Brookline Preservation Commission

Local Historic District Report

Local Historic District: Lawrence

Address: 247-249 Kent Street

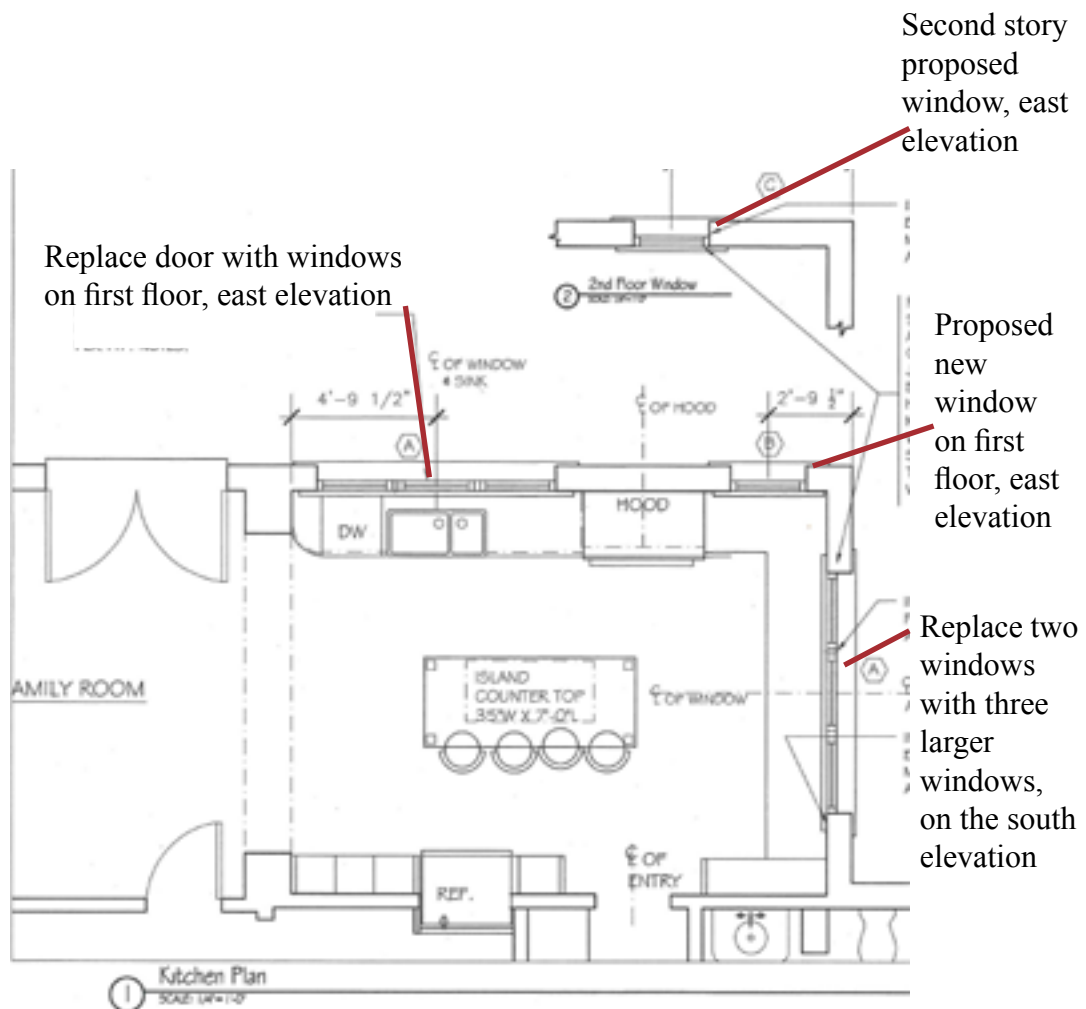
Proposed Alterations: The applicant proposes to replace a pair of non-historic windows on the south elevation with three new windows. Alterations for the east, rear elevation, are to replace a rounded wood door with three windows and to install a window on the first and second floor where ones do not exist. All windows will be wood, true divided light, single pane windows and will match existing in size and pattern. Lastly proposed is the repair and replication of the wood “stick” trim under the windows to match existing.

Preliminary Findings: The application for window and door replacement are in compliance with the guidelines.

Windows to be replaced with three windows

Door to be replaced with three windows and area where new windows will be installed.
